ADDENDUM NO. 4

Invitation to Bid (ITB) 26-23-214657

Bridge 158.7 Replacement

Alaska Railroad Corporation

FIGURE 1 OF 2

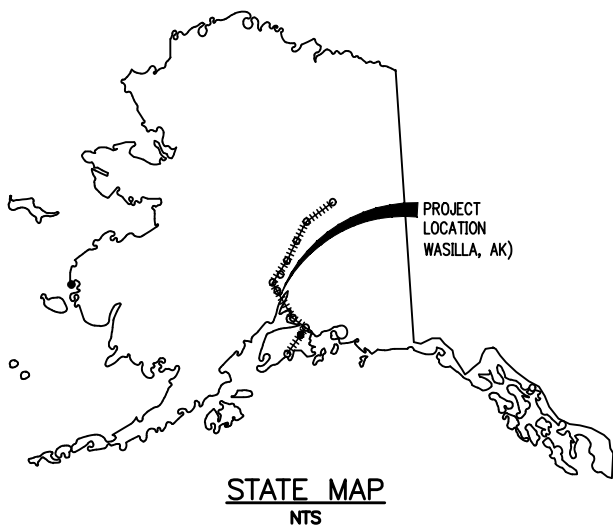
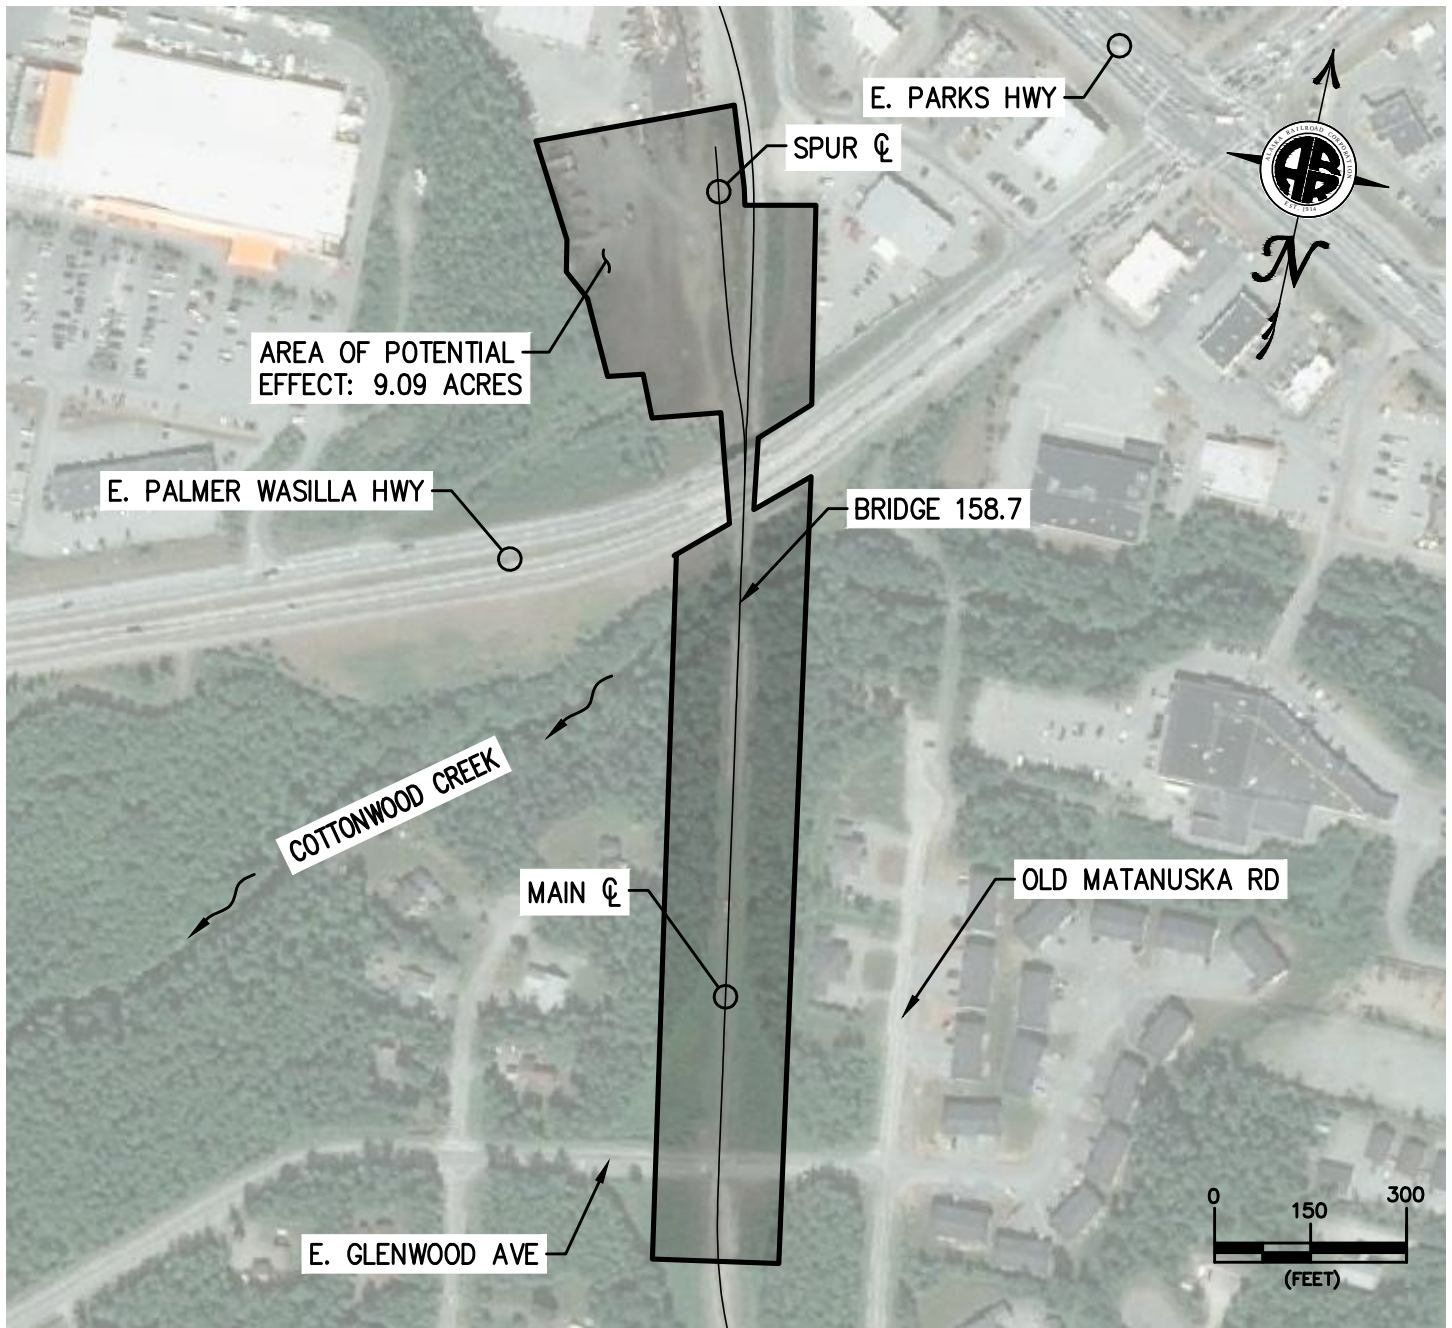
14. Access and Storage

The areas highlighted can be used for staging materials and equipment. No clearing or grubbing is permitted in these areas. The area to the east of the tracks is smaller than highlighted in the question, see the “Area of potential effect” shape in the attached APE Figures dated January 19, 2023.

FILL IMPACTS

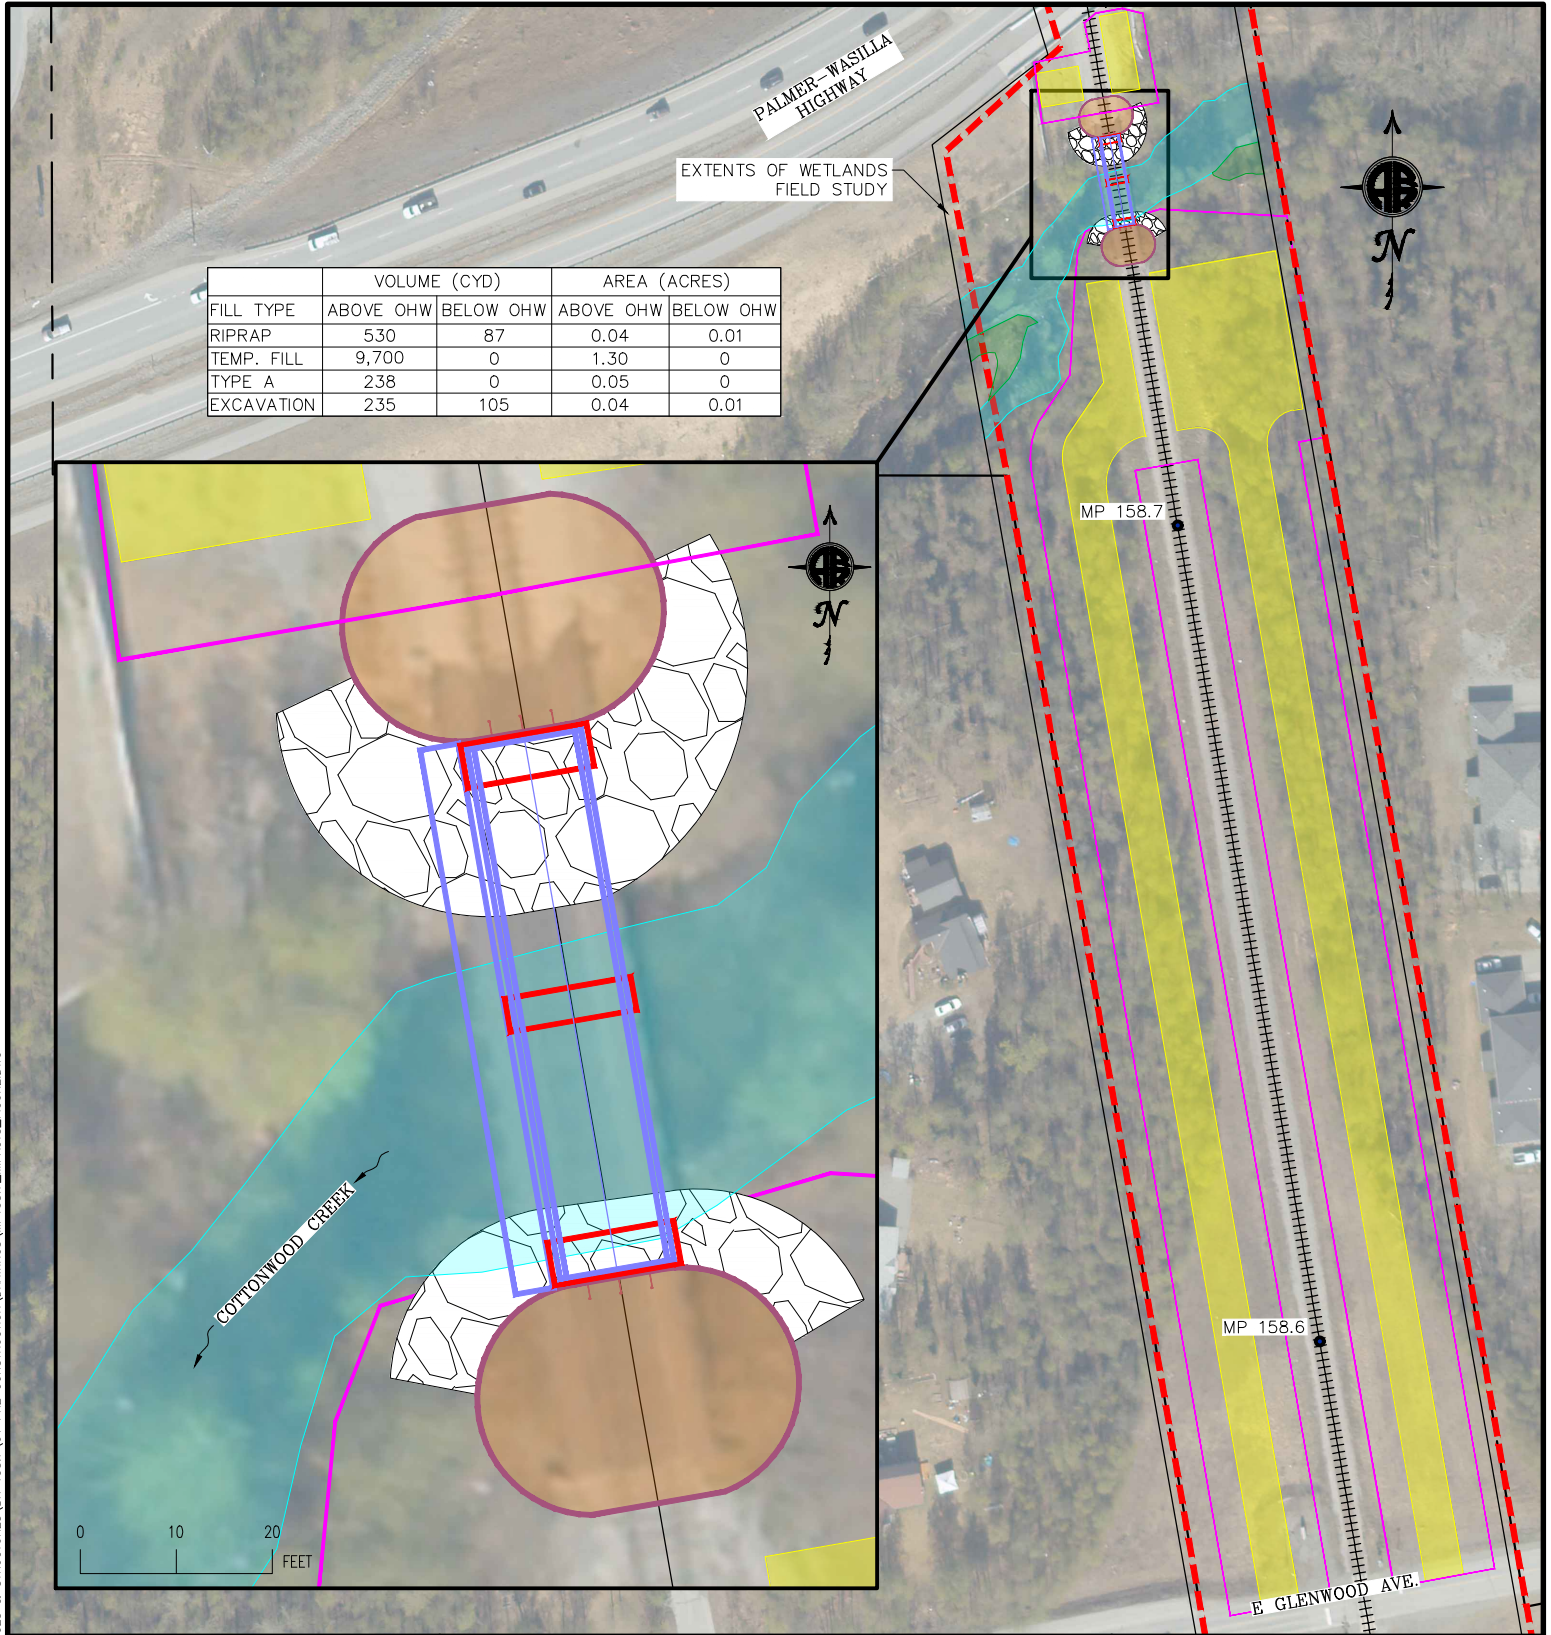
There are no permits specified in the Special Provisions or attached to the ITB Documents.

- a. What necessary permits and/or agency authorizations are required to begin work?
- b. Has the ARRC obtained the necessary permits and authorizations for the project to be constructed as designed and advertised?
- c. Have Permits and Authorizations been secured for the Temporary Access, shown in the Contract Documents?

- A. City/borough required permits, SWPPP, TWUP, TCP, and NPP (if required)
- B. ARRC is currently pursuing and coordinating required state and federal regulatory authorizations for this project, specifically the Alaska Department of Fish and Game (ADFG), the U.S. Army Corps of Engineers (USACE) Nationwide Permit (NWP) program, and the applicable Floodplain Development Permit authority. Permit review and approval processes are ongoing, and the selected contractor shall comply with all permit conditions upon issuance.
- C. See answer above (B & C combined response).
